**Re: NEETNY Comments to NYISO AC Transmission SECO Draft Report**

**NEETNY Comments on AC Public Policy Transmission Need Selection Report**

**Figure 1**

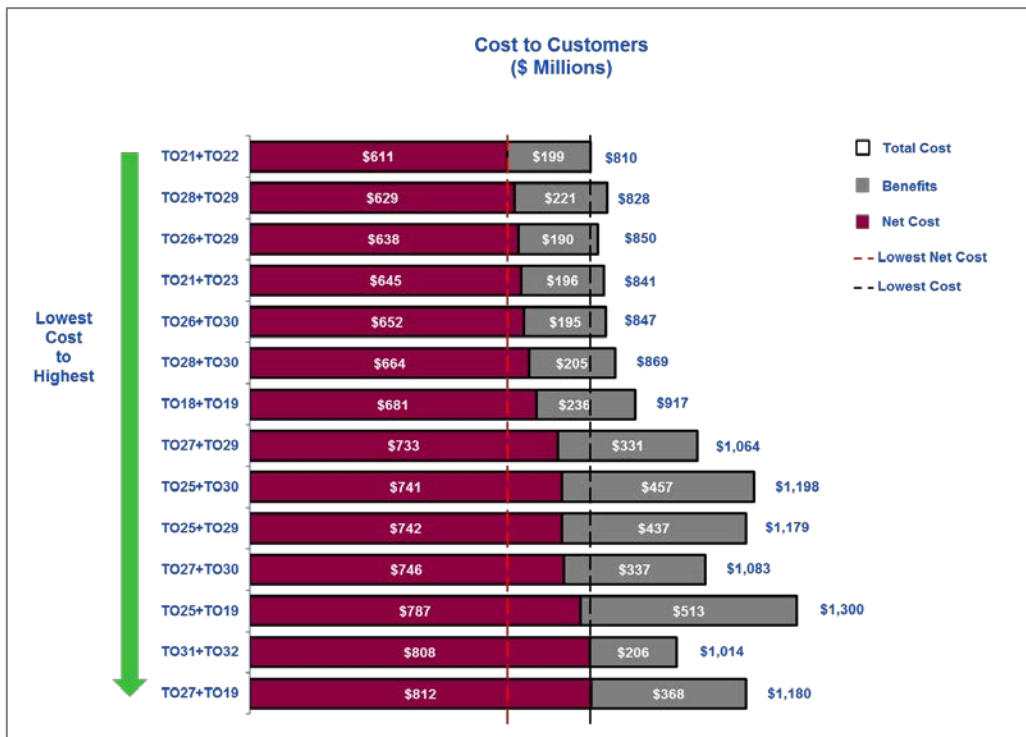
Figure 1 below depicts NYISO’s 14 project groupings, ranked in order of net cost. The chart shows that the lowest-cost combination could save New Yorkers up to approximately \$500 million in capital costs and \$200 million in net costs after factoring in the value of production costs. The combination with the lowest net cost to customers (TO21 + TO22) has a net cost of \$611 million, while the combination with the highest net cost to customers (TO27 + TO19) has a net cost of \$812 million.
